Title: STAGE 1 ROAD SAFETY AUDIT

Capdoo Link Road, Clane Co. Kildare.

Client: DBFL Consulting Engineers.

Report reference: 0572R01

LOCATION

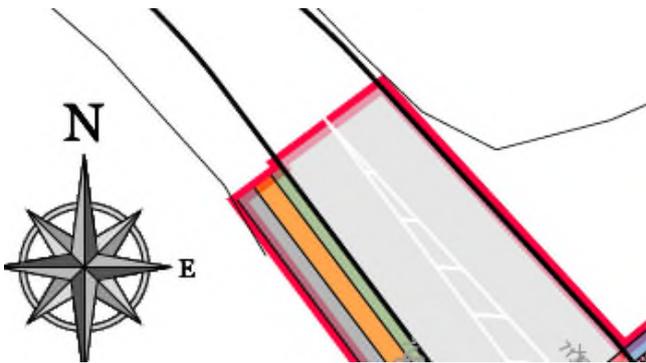
The existing cycling facilities on the R407 are on-road and the proposed cycle facilities are off-road. It is unclear how it is proposed to provide a transition from on to off-road and vice versa. Sudden changes in cyclists location on the carriageway could lead to drivers being unable to react resulting in collisions.

It is recommended that the transition details be developed during the detailed design such that cyclists can safely travel on the R407 and the new link road.

3.3	Y	Y		
3.4	Y	Y		
3.5	N	N	<p>The proposed toucan crossing has been located to maximize connectivity between the western and eastern portion of the development (i.e. between the duplex units in the south-west corner / the creche and open space areas on the eastern side of the Capdoo Link Road).</p> <p>Connectivity from College Road East to destinations such as the creche, the open space area on the eastern side of the Capdoo Link Road and the general town center (south of the site via Capdoo Lane) are easily facilitated without provision of a second pedestrian crossing on Capdoo Link Road.</p> <p>Introduction of a second crossing adjacent to College Road East as recommended would result in two signalized crossings within 80m along the Capdoo Link Road.</p>	Yes

Drawing 162074-2003

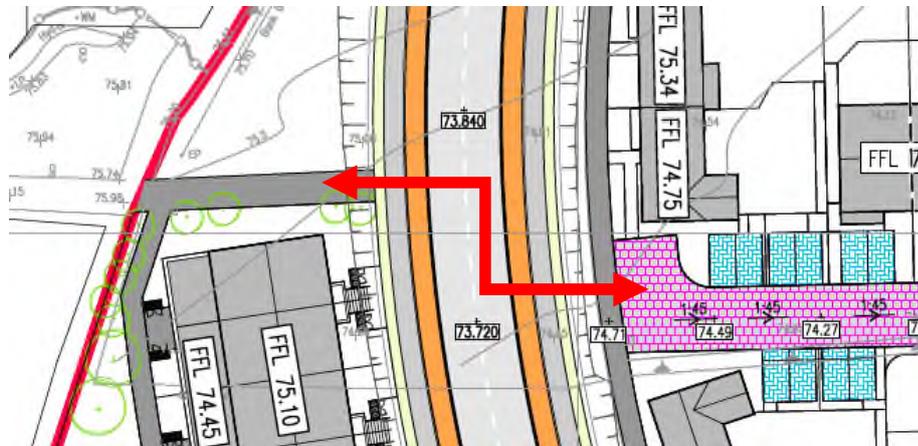
There are potential desire lines for pedestrians from College Road East to the internal cul-de-sac on the eastern side of the Link Road and similarly from Mainham Woods. There is however no provision for pedestrians or cyclists to cross at these locations. Without crossing facilities there is an increased risk of a collision with vulnerable road users.

It is recommended that formal pedestrian crossings of the Link Road are provided at the desire lines.

Paragraph No. in Safety Audit Report	Problem accepted (yes/no)	Recommended measure accepted (yes/no)	Alternative measures (describe)	Alternative measures accepted by Auditors (Yes/No)
			We note there is no proposal to facilitate connectivity between Mainham Woods and the Capdoo Link Road (due to significant level differences).

Drawing 162074-2003

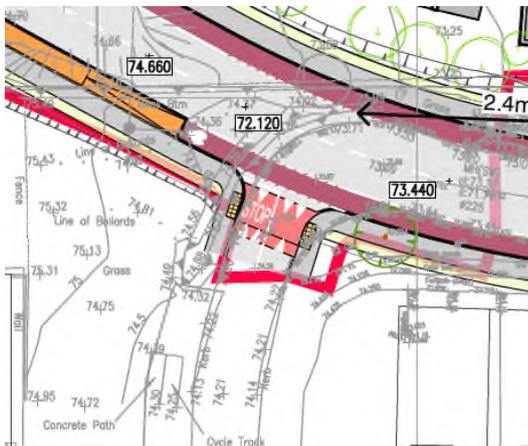
There are existing segregated footway and cycle way facilities in Capdoo Park residential estate. The proposed Link Road vulnerable road user facilities do not tie in with these segregated facilities. This may result in cyclists having to travel on the carriageway where they would be at greater risk of being struck by passing vehicles and it would be a step down from the current facilities.

It is recommended that the design be modified to maintain segregated footway and cycleway facilities in Capdoo Park.

3.7	Y	Y/N	Proposed works at the Capdoo Link Road / Capdoo Park junction extend to the existing public ownership boundary line. Capdoo Park has not yet been taken in charge by KCC and it is not possible at this stage to modify the existing segregated footway / cycleway within Capdoo Park. We will advise this item to Kildare Co Co and they can extend to meet existing path / cycle path when Capdoo Park is taken in charge.	Yes

Appendix B – Problem Location Map.

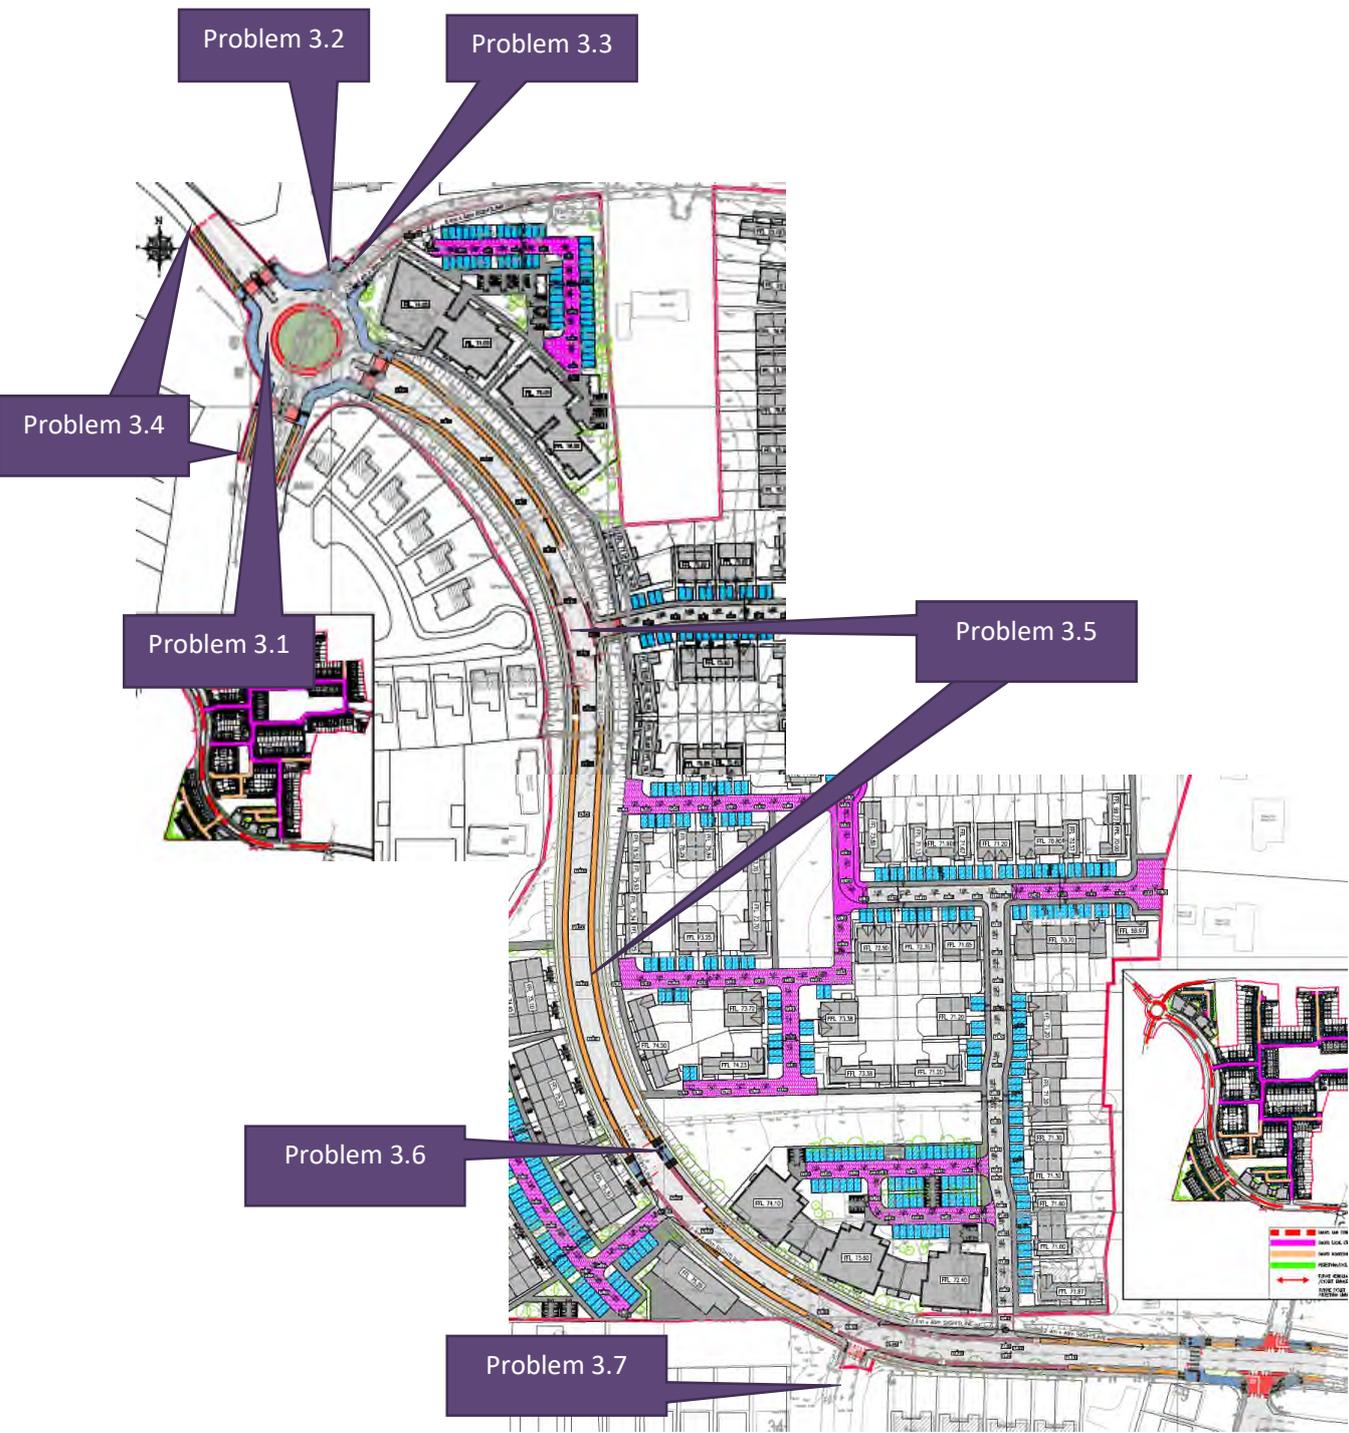
It is unclear if the proposed roundabout on the R407 will be able to cater for the swept path of heavy goods vehicles. The regional road routes have a high percentage of heavy goods vehicles and without sufficient space to accommodate the swept path of these vehicles they could overrun into the areas for vulnerable road users or cause material damage to roadside furniture.

It is unclear if the design caters for access to the premises on the north-east corner of the proposed roundabout. There is a risk that the revised access detail may lead to conflict with vulnerable road users on the footpath/cycle tracks or at the controlled crossings.

The carriageway width of the L5078 appears narrow for two vehicles to meet. If a give take system has to be used drivers may stop on the circulating carriageway of the roundabout which could result in rear end collisions.

The signalised toucan crossing at the mid-point of the Link Road is located where there is an on-road cycle lane. This could lead to drivers inadvertently travelling over the areas where pedestrians cross resulting in damage to the vulnerable road user infrastructure.

3.1	Y	Y		
3.2	Y	Y	<p>The existing access for the private dwelling is now shown on the roundabout layout plan drawing 162074-2001 Rev A.. We note that the Capdoo Inner Relief Road included a DMRB style roundabout at this location when it received Part VIII Planning from Kildare Co Co previously and the existing access location was retained in that arrangement. The provision of a DMURs style roundabout with this revised scheme enhances safety by reducing entry speeds and improving crossing facilities etc for vulnerable road users. As per drawing 162074-2001 Rev A there is sufficient setback distance from the dwelling entrance to back of shared path to allow the driver & vulnerable road user adequate visibility on approach. The bollards provided on the access also highlight to the pedestrian / cyclist on the shared path that an entrance exists at that location. The driver entering the property will yield to pedestrians / cyclists on the shared path and will be visible to all slow moving vehicles entering / exiting the roundabout.</p>	Yes

3.6	Y	Y	The cycle lanes (or road / off road) have been amended so that the crossing is sited where the cyclists are on road. Tactile paving & signal poles have been relocated to the edge of the pedestrian footpath (i.e. clear of the on road cycle lane)	Yes
